St. Lucie Unit 1 and Unit 2
Docket Nos. 50-335 and 50-389
Proposed License Amendments
Containment Spray and Cooling Systems

ST. LUCIE UNIT 1 MARKED-UP TECHNICAL SPECIFICATION PAGES

ST. LUCIE UNIT 2 MARKED-UP TECHNICAL SPECIFICATION PAGES

Page B 3/4 6-3

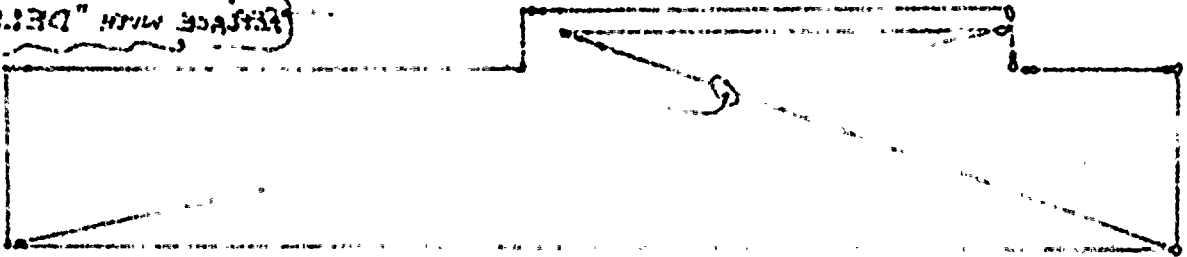
3/4.6.2.3 ~~CONTAINMENT COOLING SYSTEM~~

REPLACE WITH "DELETED"

~~The OPERABILITY of the containment cooling system ensures that 1) the containment air temperature will be maintained within limits during normal operation, and 2) adequate heat removal capacity is available when operated in conjunction with the containment spray systems during post-LOCA conditions.~~

Page 3/4 6-15

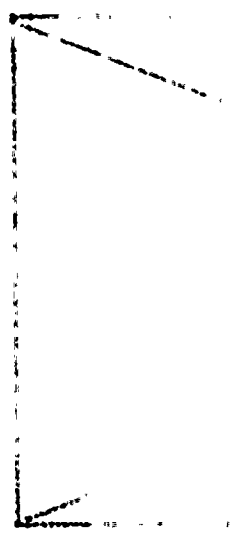
REPLACE
with
INSERT-A

~~3.6.2.1 Two independent containment spray systems shall be OPERABLE with each spray system capable of taking suction from the RWT on a Containment Spray Actuation Signal and automatically transferring suction to the containment sump on a Sump Recirculation Actuation Signal. Each spray system flow path from the containment sump shall be via an OPERABLE shutdown cooling heat exchanger.~~

~~Applicable only when pressurizer pressure is > 1750 psia.~~

DELETE

REPLACE
with
INSERT-A

DELETE

3.6.2.1 Two containment spray trains and two containment cooling trains shall be OPERABLE.

APPLICABILITY: Containment Spray System: MODES 1, 2, and MODE 3 with
Pressurizer Pressure \geq 1750 psia.

Containment Cooling System: MODES 1,2, and 3.

- a. With one containment spray train inoperable, restore the inoperable spray train to OPERABLE status within 72 hours and within 10 days from initial discovery of failure to meet the LCO; otherwise be in MODE 3 within the next 6 hours and in MODE 4 within the following 54 hours.

- b. With one containment cooling train inoperable, restore the inoperable cooling train to OPERABLE status within 7 days and within 10 days from initial discovery of failure to meet the LCO; otherwise be in MODE 3 within the next 6 hours and in MODE 4 within the following 6 hours.

- c. With one containment spray train and one containment cooling train inoperable, concurrently implement ACTIONS a. and b. The completion intervals for ACTION a. and ACTION b. shall be tracked separately for each train starting from the time each train was discovered inoperable.

- d. With two containment cooling trains inoperable, restore one cooling train to OPERABLE status within 72 hours; otherwise be in MODE 3 within the next 6 hours and in MODE 4 within the following 6 hours.

- e. With two containment spray trains inoperable or any combination of three or more trains inoperable, enter LCO 3.0.3 immediately.

- a. With one containment cooling train inoperable, restore the inoperable cooling train to OPERABLE status within 72 hours; otherwise be in MODE 4 within the next 6 hours.
 - b. With two containment cooling trains inoperable, enter LCO 3.0.3 immediately
